# Access Compliance Report

## Public Rights-of-Way

### (Curb Ramps)

Intersection ID: 48409	Main Street: GLADWYNE_PL	Cross Street: BRYN_ATHYN_CT	Location: SE
ADA ID: DD77B0663597	Ramp Type: PerpDiag	Initial Pass/Fail: Fail	Overall Compliance: No
		Severity Score: 13.75

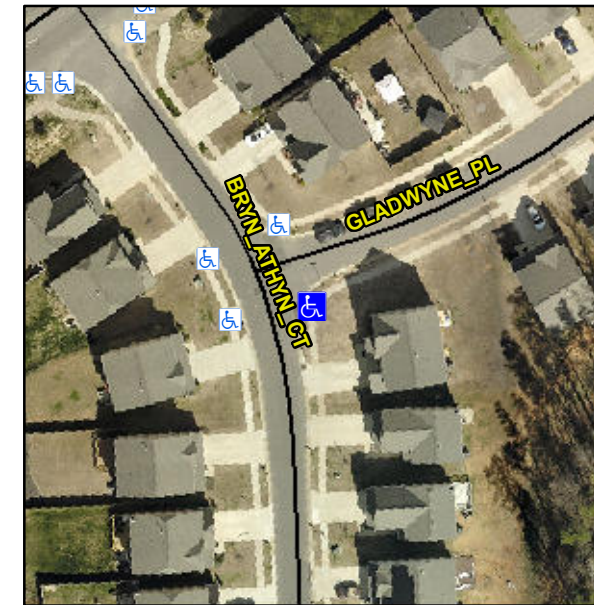
**Not Found, R304.2.2, R304.5.3**

Compliance	Description	Data	Compliance	Description	Data
N/A	Ramp Length (in)	46.5	No	Ramp Slope (%)	9.3
Yes	Ramp Width (in)	48.0	No	Ramp XSlope (%)	3.1
N/A	Flare Type LT	N/A	N/A	Flare Type RT	N/A
N/A	Flare Slope LT (%)	N/A	N/A	Flare Slope RT (%)	N/A
N/A	Flare Traversable LT?	N/A	N/A	Flare Traversable RT?	N/A
N/A	Landing Length (in)	N/A	N/A	DWS Provided?	N/A
N/A	Landing Width (in)	N/A	N/A	DWS Contrast?	N/A
N/A	Landing Slope (%)	N/A	N/A	DWS Length (in)	N/A
N/A	Landing X Slope (%)	N/A	N/A	DWS Full Width?	N/A
N/A	Landing Curb? (Y/N)	N/A	N/A	DWS Offset (in)	N/A
N/A	Shared Landing?	N/A			
N/A	Gutter Ponding?	N/A	N/A	Gutter Slope (%)	N/A
N/A	Gutter Lip Ht (in)	N/A	N/A	Gutter X Slope (%)	N/A
N/A	Painted X Walk1?	No	N/A	Painted X Walk2?	No
	X Walk 1 Direction	To N		X Walk 2 Direction	To W
N/A	X Walk 1 Width (in)	N/A	N/A	X Walk 2 Width (in)	N/A
	X Walk 1 Slope (%)	1.7		X Walk 2 Slope (%)	2.2
	X Walk 1 X Slope (%)	1.2		X Walk 2 X Slope (%)	2.6

**Remove & Replace Curb Ramp With Two New Directional Ramps or Equivalent.**
